**Barr Lake/Milton Reservoir Watershed Association
Tech Committee Meeting
March 23rd, 2023, 9:00 – 11:30 am
Virtual Only**

Tech Committee Meeting Minutes

MS4 Baseline Loading – City and County of Denver has consulted GEI to quantify their contribution to the TMDL MS4 Wasteload Allocation. We will review the progress to date and help answer any questions to guide the analysis due April 1st, 2023.

KEY DOCUMENTS REVIEWED

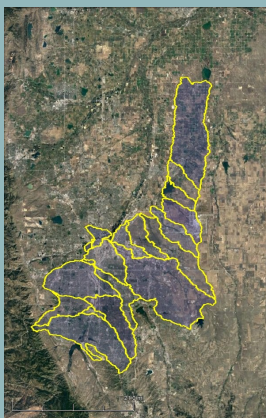
- a. They ran into trouble getting ahold of a functioning SWAT model.
- C. There were 19 subbasins in the watershed, with other outlier basins likely crossing over due to plumbing; 14 subbasins primarily influence Barr Lake, along with 126 HRUs (hydrological units). The HRU shapefile wasn’t available for the analysis, unfortunately.

- D. GEI recognizes that this modeling effort guided the TMDL, but didn’t provide exact numbers. Much was based on the consultant’s “Best Professional Judgement”. Additionally, these numbers are older and much has changed since then. For this analysis and reduction goal, these numbers must be used to provide a baseline to work from.
